DOCUMENTATION TRANSMITTAL

Documentation Description: Nonconformance Reports -
C-03732
C-03736
C-01006

MIDLAND PROJECT
QUALITY ASSURANCE
DEPARTMENT

NONCONFORMANCE REPORT

ATTACHMENT #1

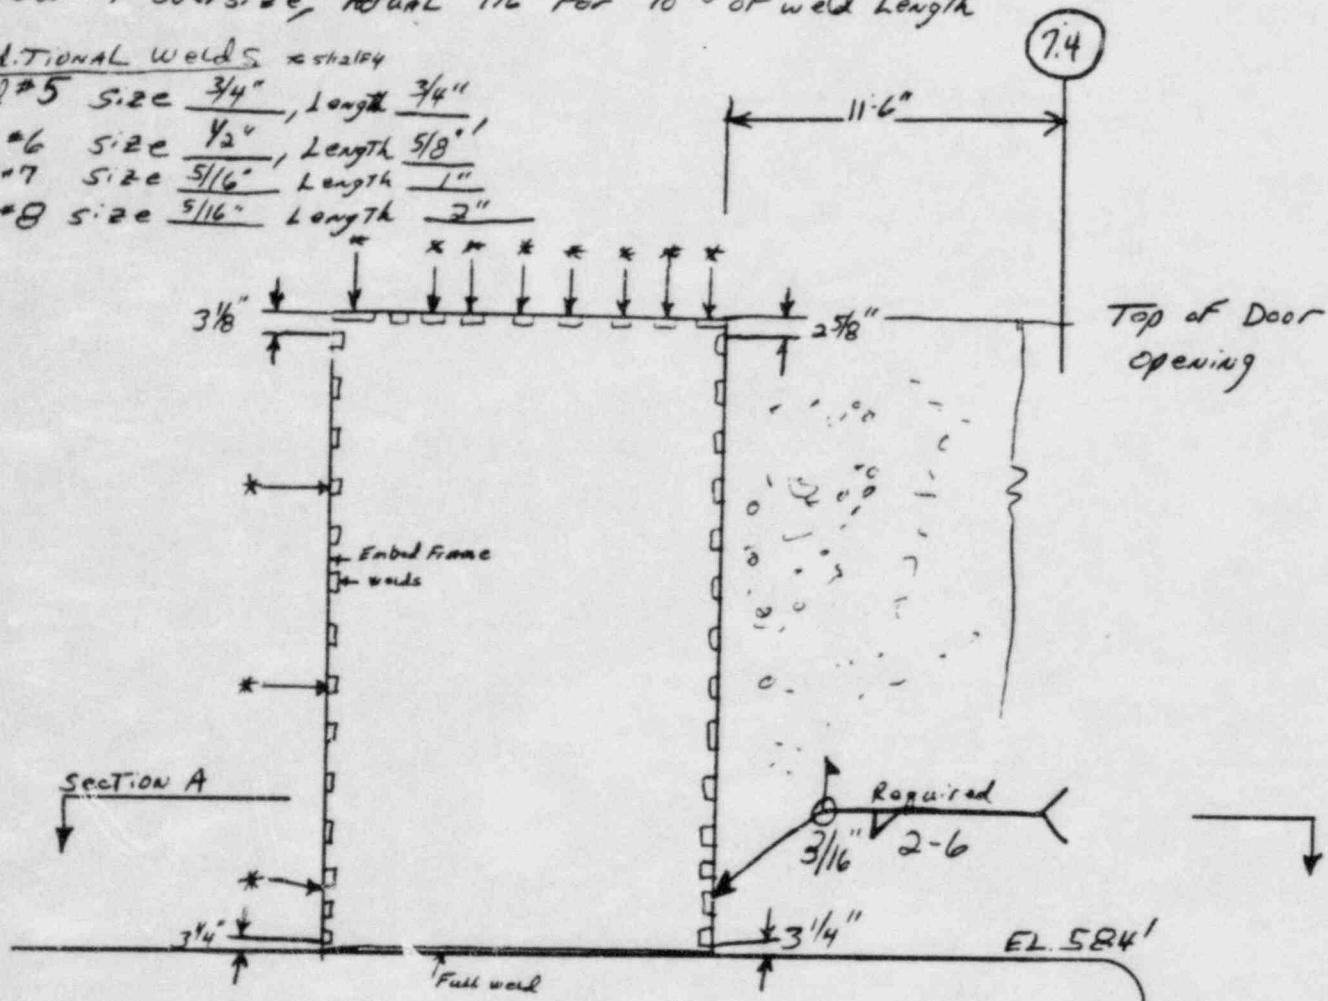
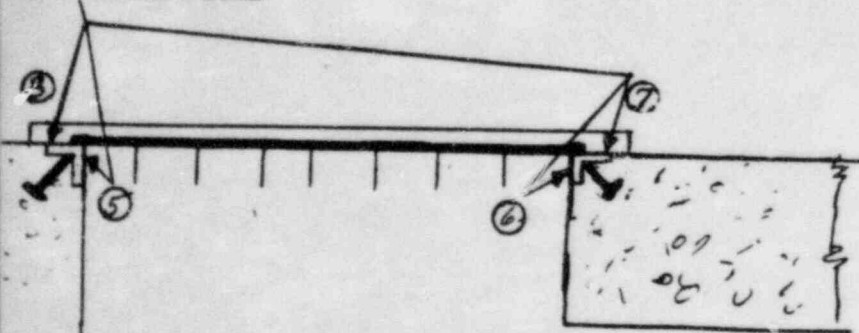
(4) The intermittent fillet welds ($\frac{3}{16}$ " - 2" long + 6" pitch) connecting Door Frame to Embedded Angle does NOT have increments at the ends. See Attachment #1. This ^{APPL. 05} ~~APPL. 05~~ _{11/25/84} applies TO THE VERTICAL ENDS OF THE FRAME ONLY.

(5) The welds identified with a * symbol on Attachment 1 are those with weld sizes in excess of $+\frac{3}{16}$ ". The avg. actual size is $\frac{7}{16}$ " for entire weld. Welds *3 oversize and *4. (see Attach 1)

(6) Additional welds indicated on attached sketch section "A" ^{ARE} ~~ARE NOT~~ _{11/25/84} shown on drawings.

Note: $\frac{1}{4}$ " ground off of weld *7 (length), these welds ^{CONNECT} ~~WALL~~ _{11/25/84} Embedded Angle Frame to Embedded Floor-Angle Frame.

- ① The symbol * indicates (oversize welds, #1) $\frac{1}{16}$ "
- ② Weld #3 oversize, actual $\frac{7}{16}$ " for 10% of weld length
- Weld #4 oversize, actual $\frac{7}{16}$ " for 10% of weld length

- ③ Weld #5 size $\frac{3}{4}$ ", length $\frac{3}{4}$ "
- Weld #6 size $\frac{1}{2}$ ", length $\frac{5}{8}$ "
- Weld #7 size $\frac{5}{16}$ ", length 1"
- Weld #8 size $\frac{5}{16}$ ", length 2"

Door # 210

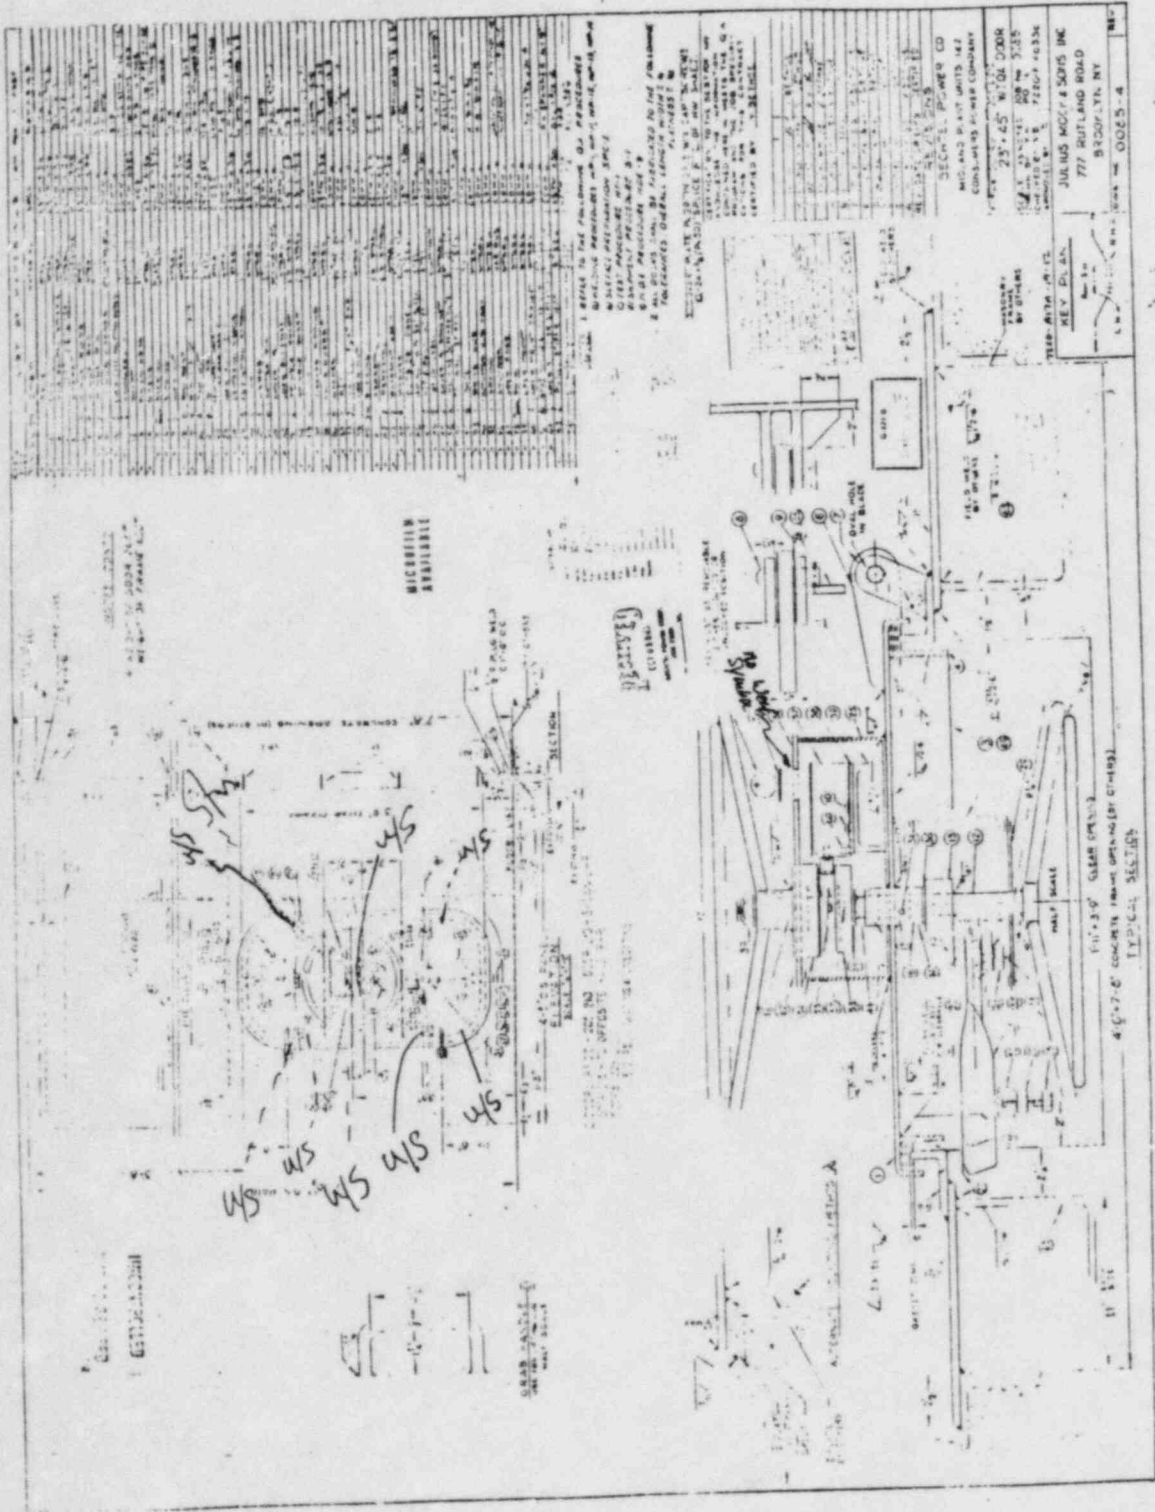
u/c = undercut
 u/s = under size
 IF = incomplete finish

Rev # 65(c)

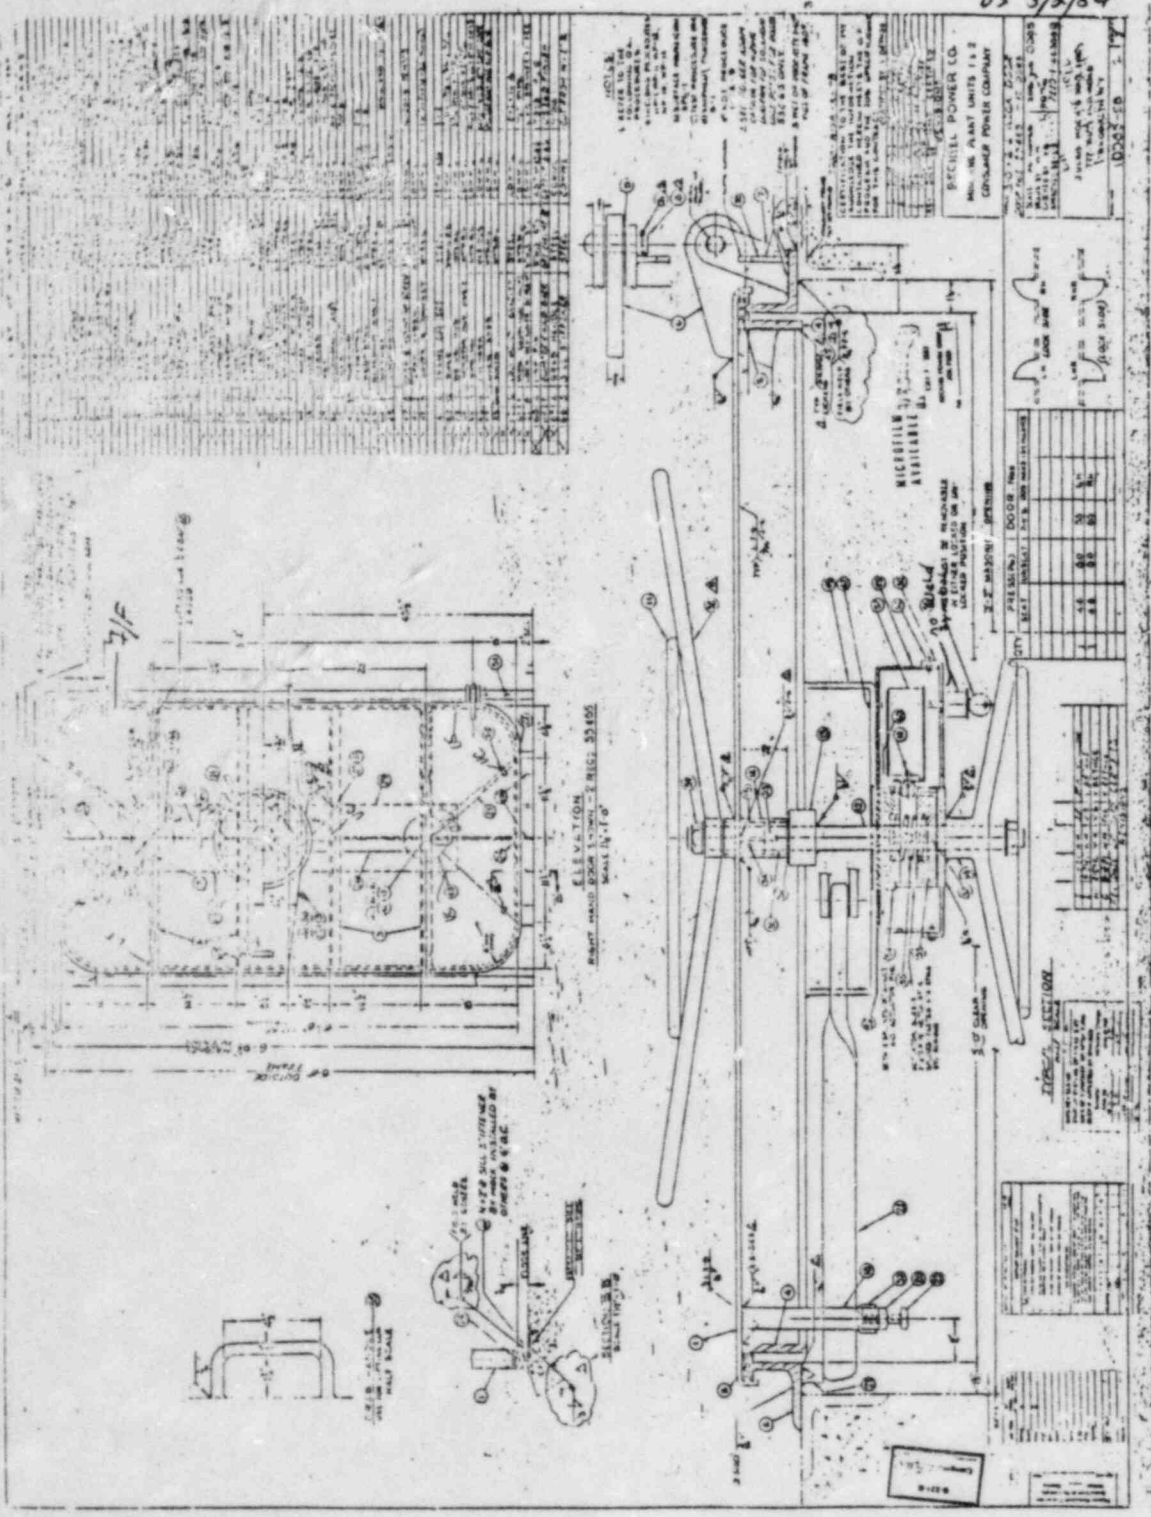
L.F. = Lack of Fusion
 U/S = under size
 U/C = undercut
 I/F = incomplete fusion
 C/L = cold lap/roll

Door #43 ©

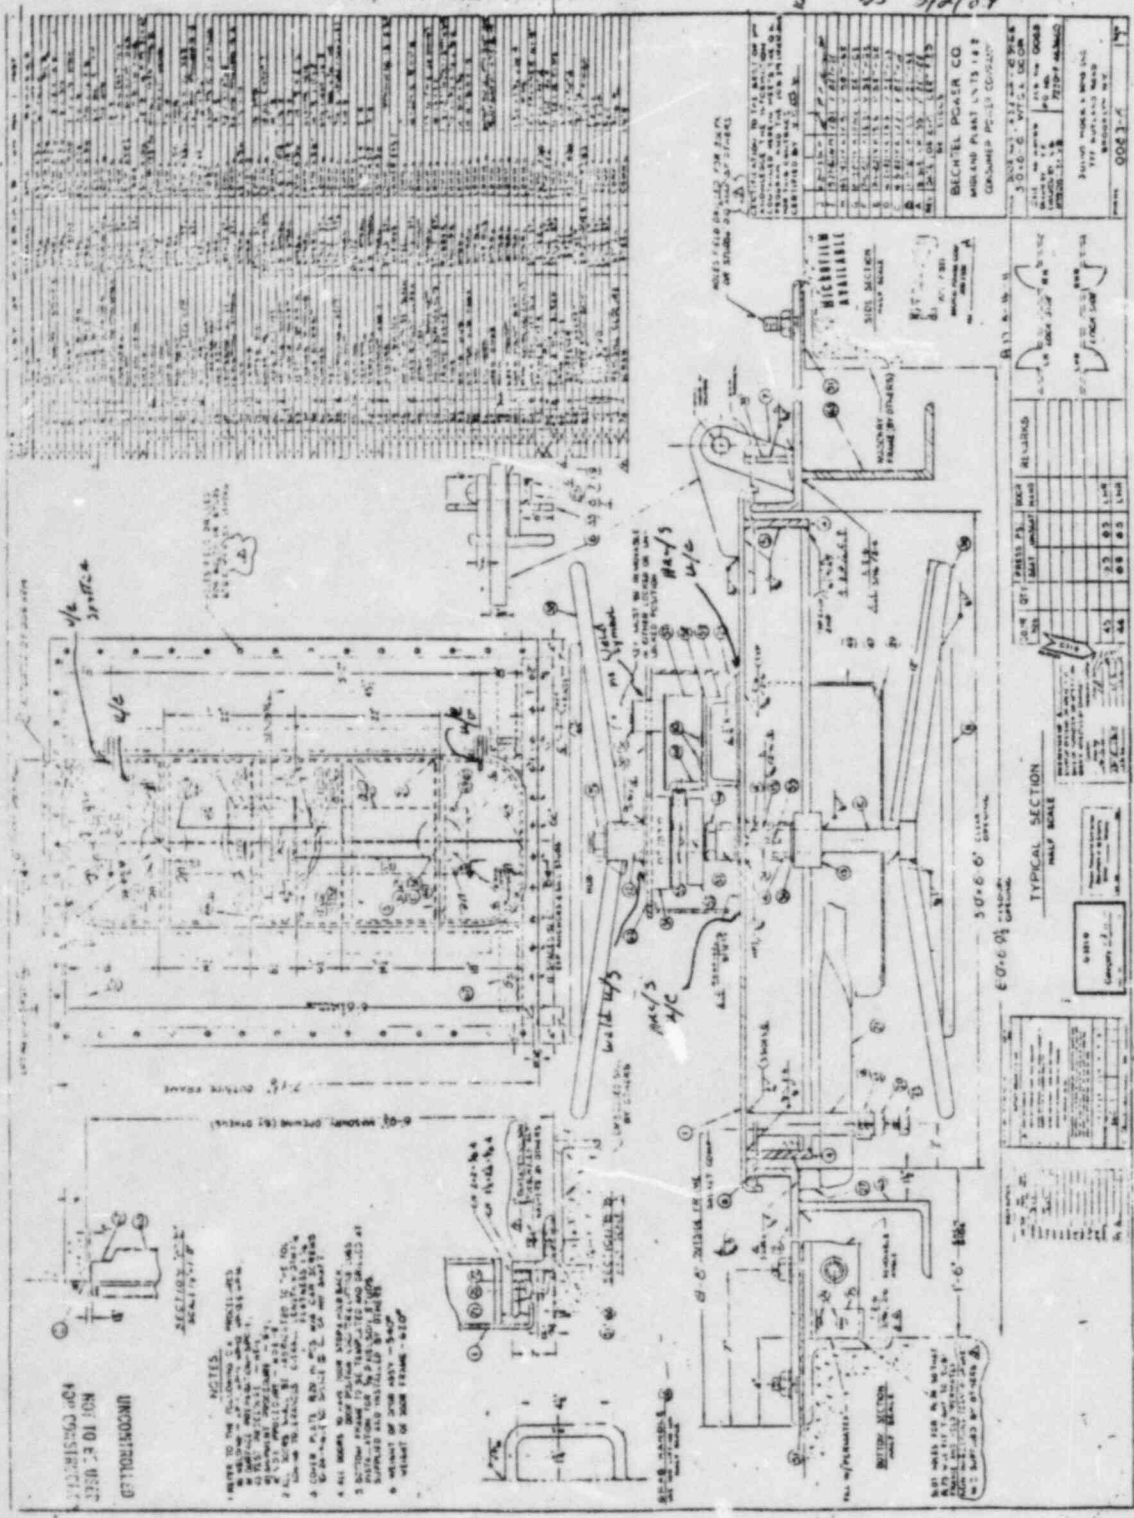
4/c = undercut
 4/s = under-size
 4/f = are smokes
 4/g = lack of finish
